PRODUCT CHANGE NOTICE

PCN#15-014

ZFAT Series - SSS173 Case Style

Change of DC and Ground Terminals to improve electrical isolation

(See attached before/after drawing)

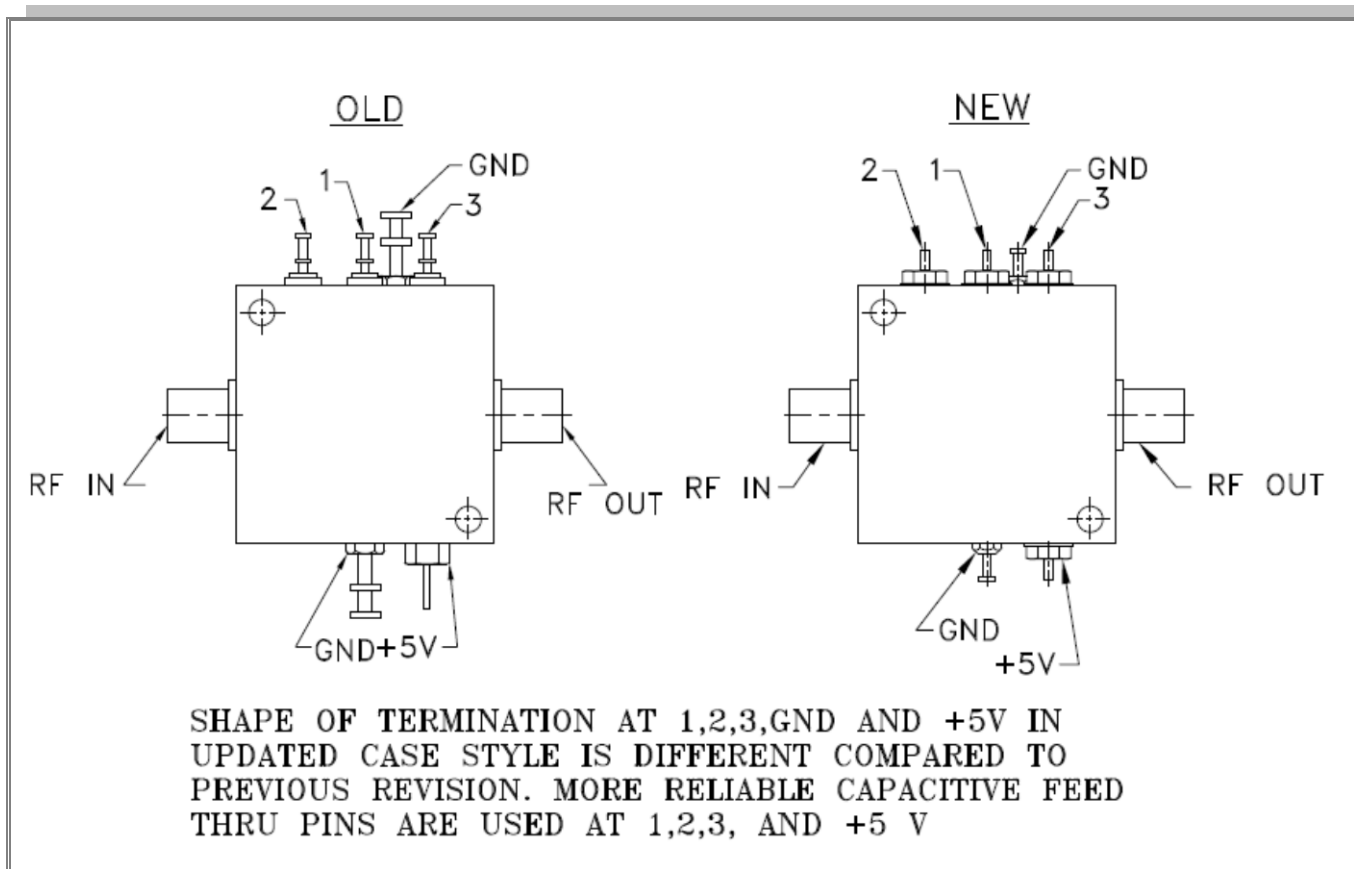
Minor change of FORM and FIT, Improvement in FUNCTION
